Planning & Zoning Commission

REGULAR MEETING

Thursday, October 28, 2021 @ 6:00 P.M.

Re: Site Plan Comment Responses
Heritage Hills Multi-Family
NWQ US 67 & Heritage Hills Parkway
DEC No. 10551

ISSUE DATE 10/20/21	DEC FILE NO. 10551
CITY FILE NO. -	SHEET NO. C2.1

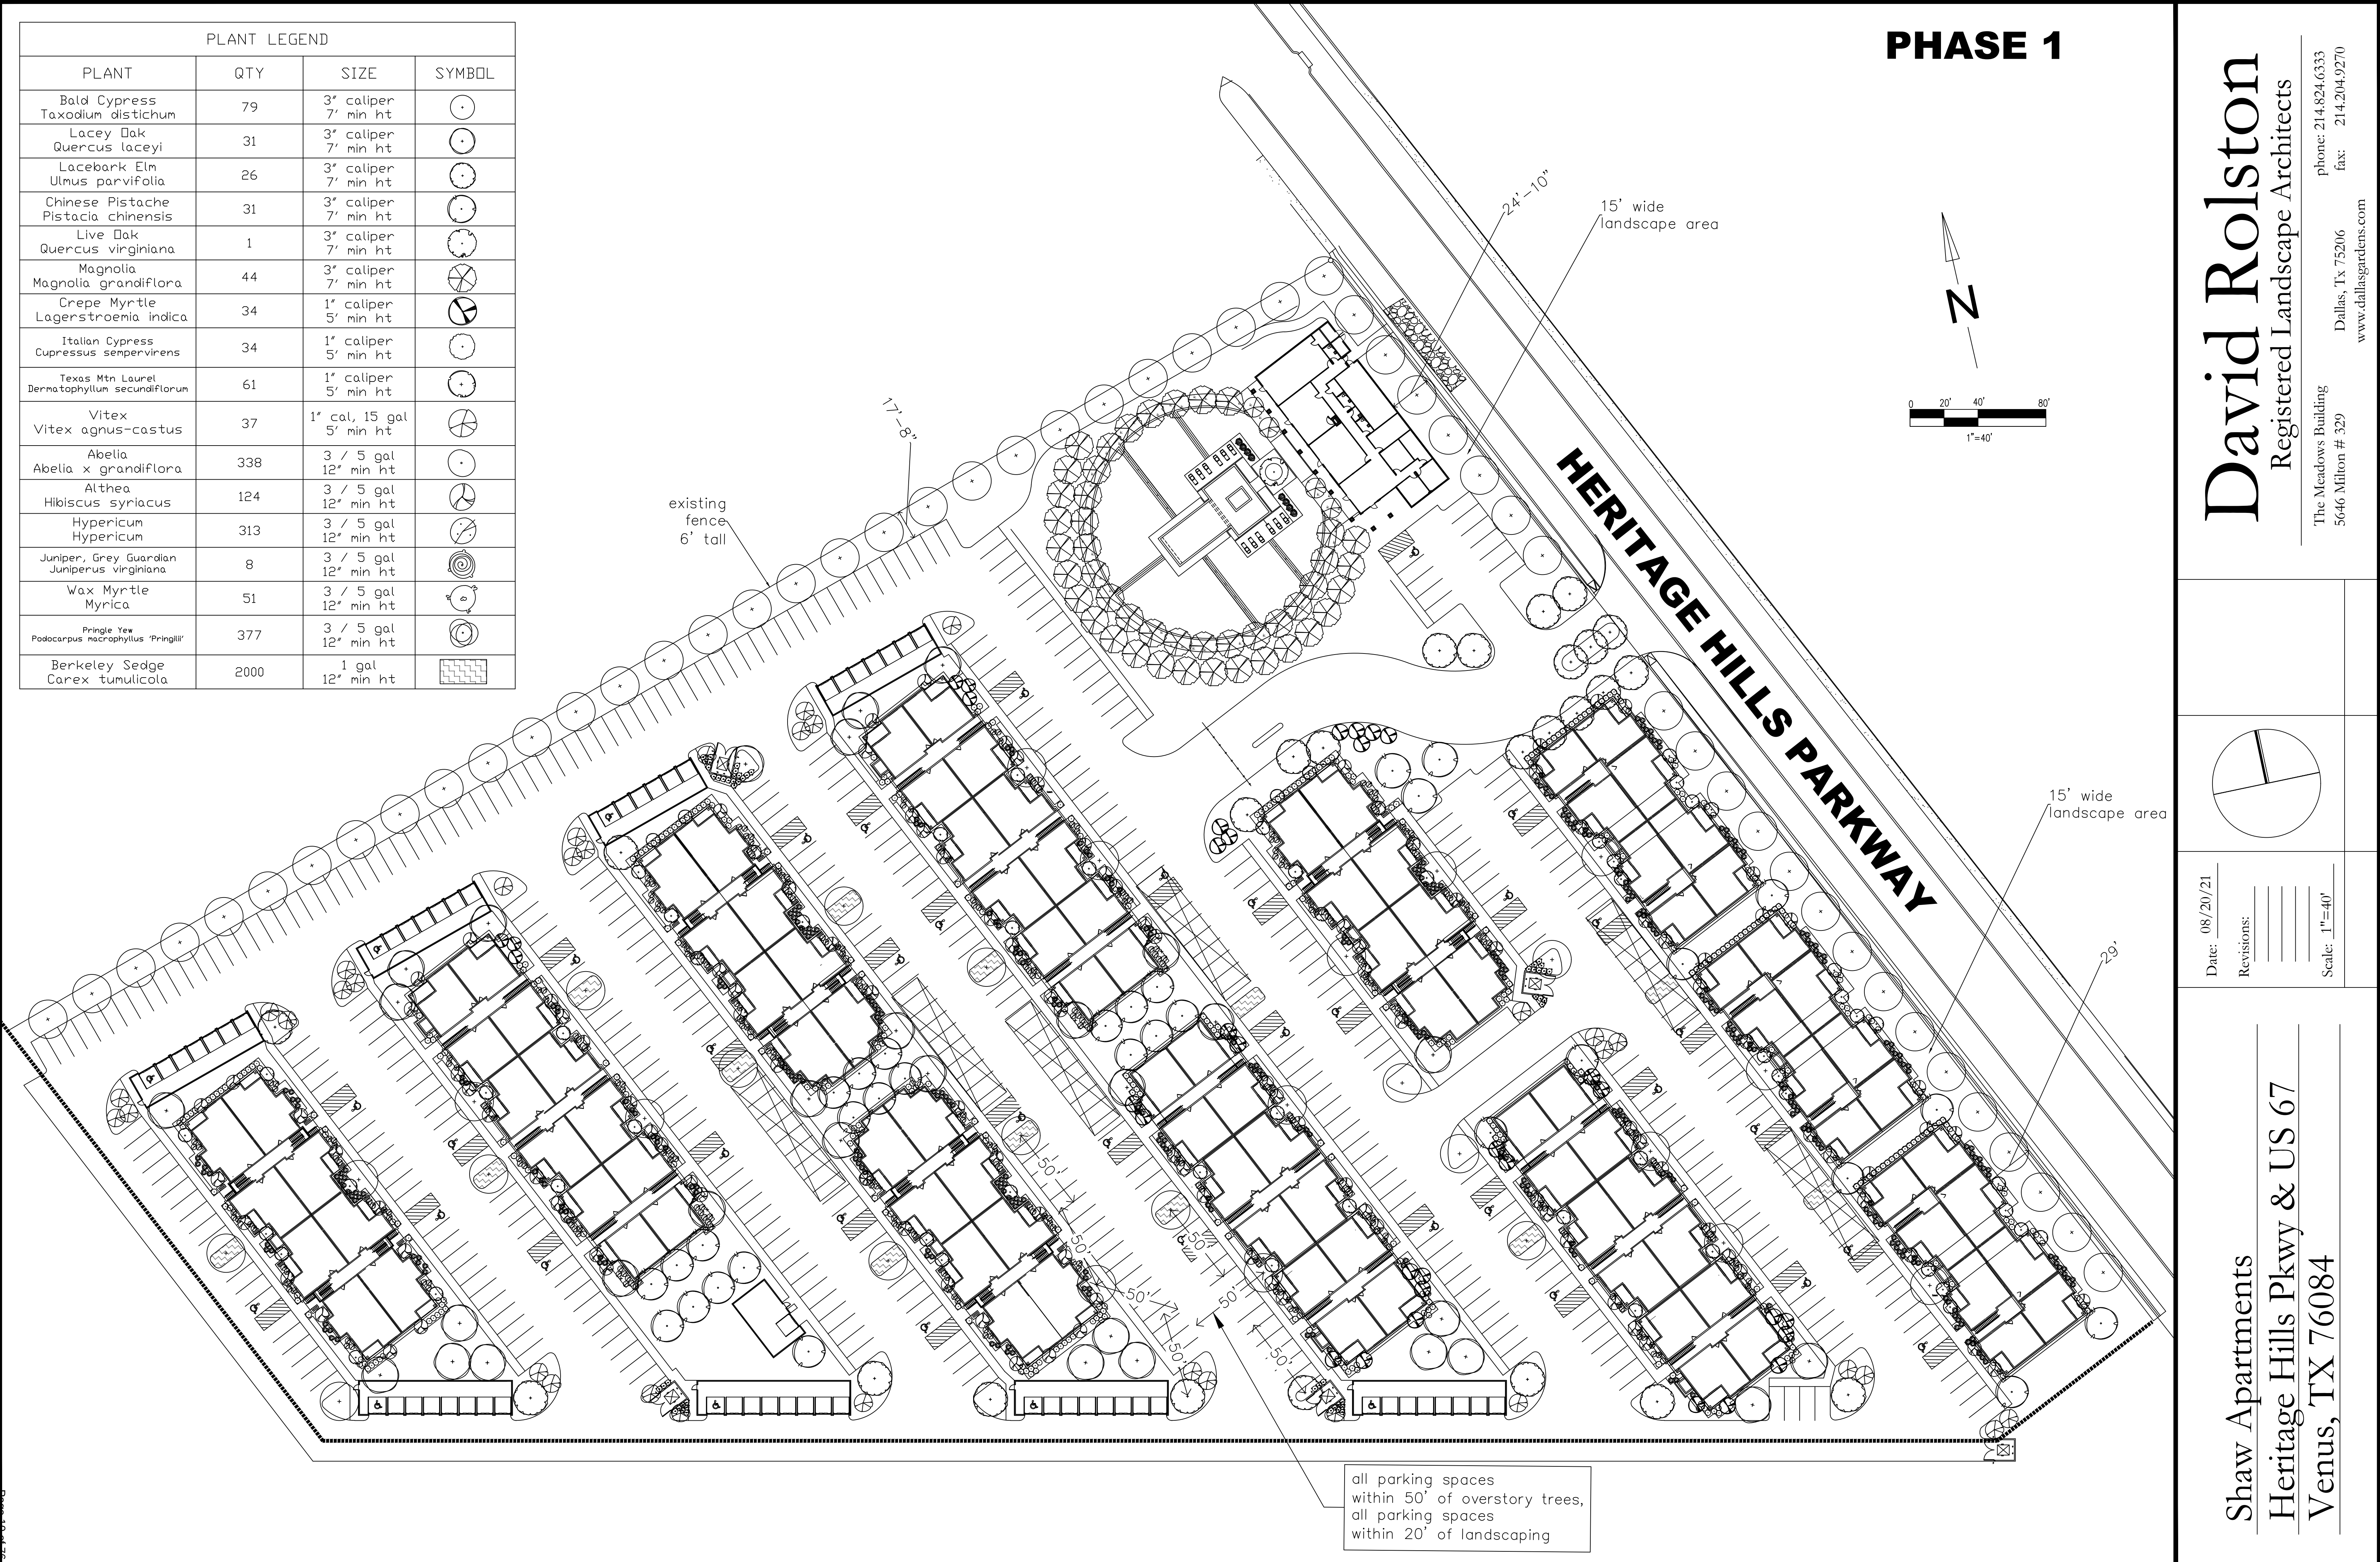
Comment	Response
SITE PLAN – SHEET C2.1	
1. The PD Site Plan is being evaluated against PD Ordinance No. 660-2018-06. Any criteria not addressed by the PD Ordinance are evaluated against the City of Venus Zoning Ordinance and Subdivision Ordinance.	Comment acknowledged.

2. Please clarify the acreage of Phase I, Phase II and the remainder the tract. Please clarify the differences between the “Provided – Phase I” and “Full Build out” columns in the Site Data table. I assume that Full Buildout includes both Phase I and Phase II.	Added a column showing data for Phase 2 and re-named “Full Buildout” column to Total, which includes both phases.

3. Please provide “elevation views or renderings indicating architectural design”, proposed building materials (PD Ordinance calls for 70 percent masonry) and window orientation, and locations of building entrances and exits.	Elevations are intended to meet PD requirements and will be provided upon completion.

4. Please provide dimensions and proposed construction of proposed drives and parking spaces. Please note that fire lanes with fire hydrants shall be 26-feet wide. Please show the curve radii for each turn of the fire lane.	Added labels and dimensions

5. Will entrances be open or gated?	Gated. Added labels.

6.	We note a proposed 5-foot sidewalk along Heritage Hills Parkway. Please show it extending to the south drive approach. Please show how pedestrians may enter the facility.	Extended sidewalk.

7.	Please show the proposed fire hydrant locations on the site plan and/or the water and sanitary sewer layout.	Added hydrants to both plans.
LANDSCAPE PLAN

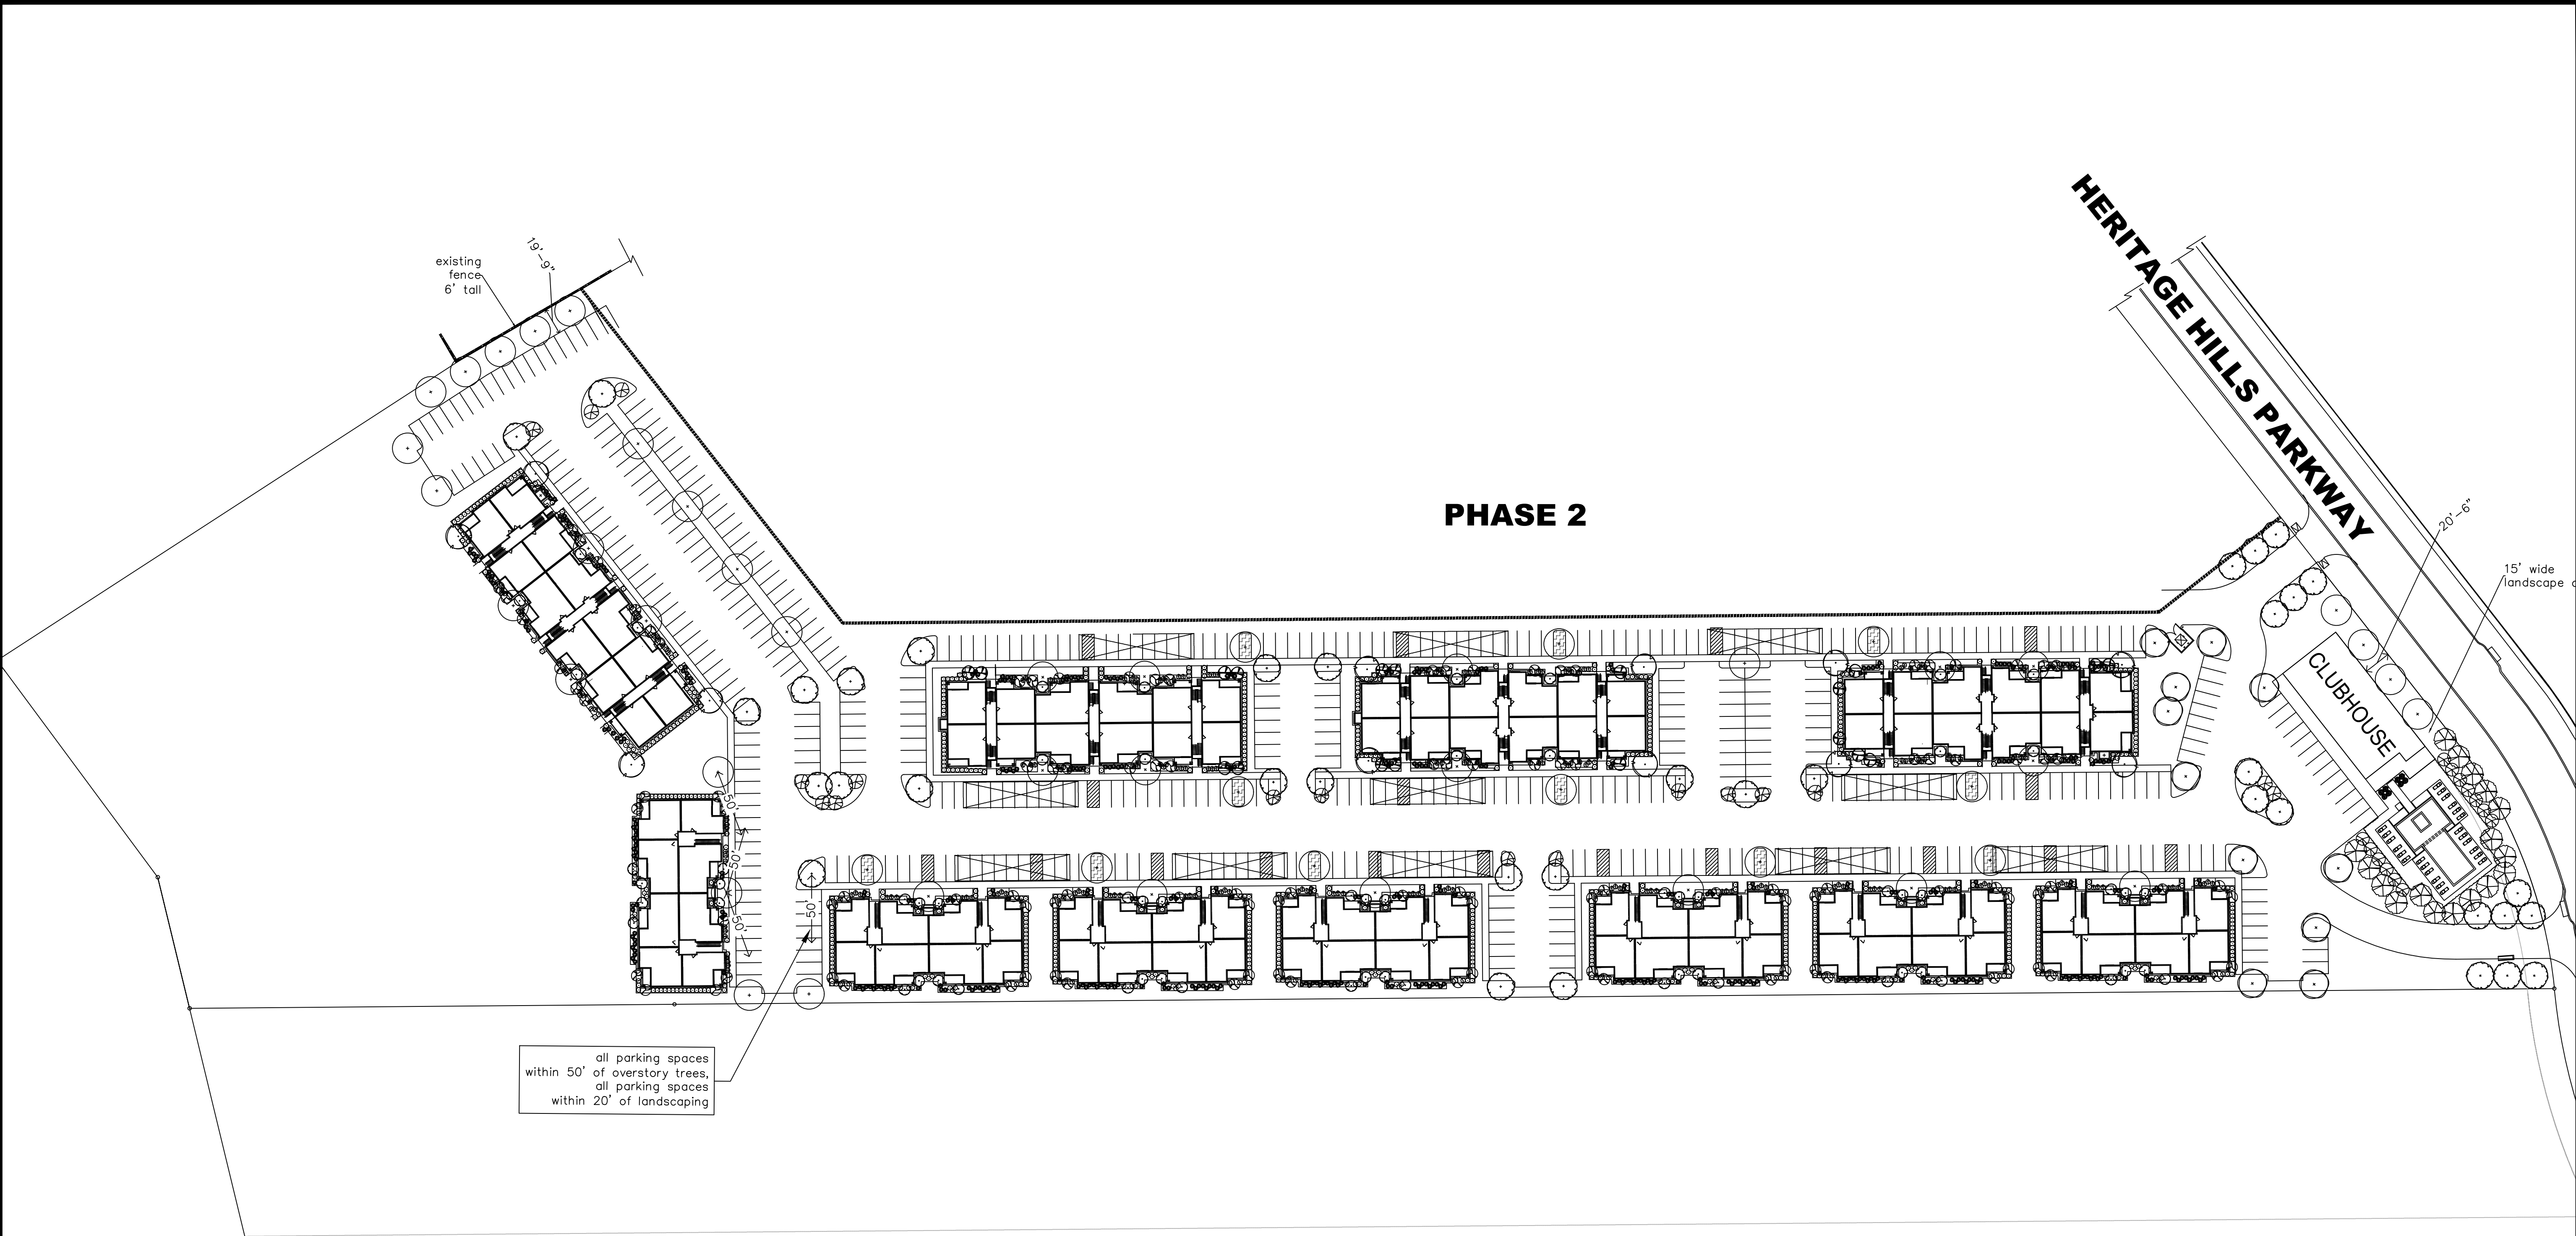
8.	Please add a scale and north arrow.	Added scale and north arrow.
9.	No screening is shown along the north property line between the multi-family and the four-plexes to the north. At a minimum, a six-foot fence shall be shown along with a 20-foot wide landscaped buffer. We note that the PD Ordinance does not require fencing along property lines. The PD Ordinance also calls for trees to be planed every 30 feet adjacent to property zoned single family (including four-plexes.)	Added trees along the north side and labeled the existing fencing. There is no minimum dimension for the landscape requirement in the PD other than what is adequate to support the required trees.

10.	Most of the species call-outs are too small to read. Please provide a key to the plant types.	Added plant legend.
11.	Please show a 15-foot wide landscape area along the Heritage Hills Parkway frontage.	Labeled the landscape buffer along Heritage Hills.

12.	Please demonstrate that every parking space is within 50 feet of an overstory tree and within 20 feet of a landscaped area.	Added note to confirm distance requirement as well as some representative dimensions. Dimensioning the entire plan decreased clarity.
ENGINEERING
